**STAFF FINDINGS**

**Staff has examined the merits of the proposed development for compliance with the Kalama Municipal Code, Kalama Development Guidelines and Public Works Standards, and State Environmental Policy Act.**

Figure 6: Preferred Concept 5B

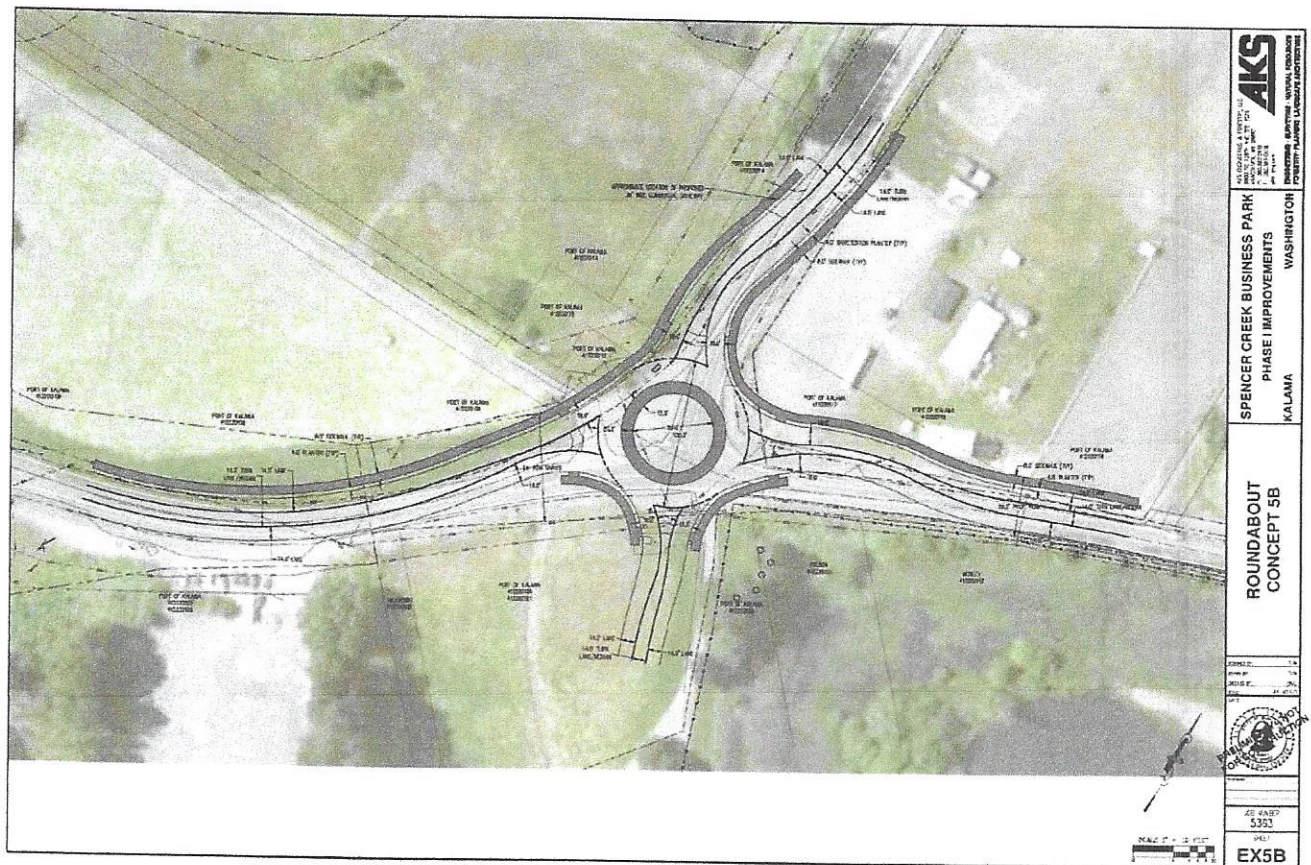
1. As briefly noted in the comments, the center of the proposed roundabout is shifted west of the existing intersection to avoid wetland and buffer impacts along the southeast quadrant. It should also be noted that the preferred alignment is considered the best solution because not only does it avoid wetland and buffer impacts, but it also situates the roundabout on soils that are likely more stable, and it helps minimize fill and other grading impacts. Additionally, it avoids encroachment onto adjacent properties in the southeast quadrant and the jurisdictional ditch in the northwest quadrant.

As discussed in the Alternatives Analysis, numerous iterations were analyzed to find a best fit intersection solution given many constraints. Analysis of the five identified goals are discussed in the Alternative Analysis. The review comments state that the north Old Pacific Highway approach appears inferior because it is not perpendicular to other alignments. Admittedly, in a perfect scenario when a roundabout can be designed and constructed on undeveloped land with no constraints, perpendicular alignments/approaches are generally preferable. However, as noted above, the proposed roundabout must accommodate numerous constraints and meet the identified project goals. The reviewer asserts that the north Old Pacific Highway approach will result in speed control issues and large vehicle turning difficulties. The speed control considerations are important, but the roundabout layout is dictated by a number of items. It should be noted that the City has previously verbally agreed that the posted speed on Old Pacific Highway and Kalama River Road will be changed to 25 MPH with the proposed Phase 1 improvements. The applicant requests that the City provide a memo clearly stating that they stand behind the implementation of this reduced speed limit. Given proper law enforcement and typical acceptable driving habits, the applicant cannot assume drivers will "drive at the perceived highest achievable speeds." In addition to the required traffic control items (roundabout ahead, yield, etc. signage and striping) shown on the plans, the applicant would like to propose delineating, with additional striping on the roundabout legs and circulatory lane, to address the reviewer's concerns about delineating a single travel lane (see response to #2-4
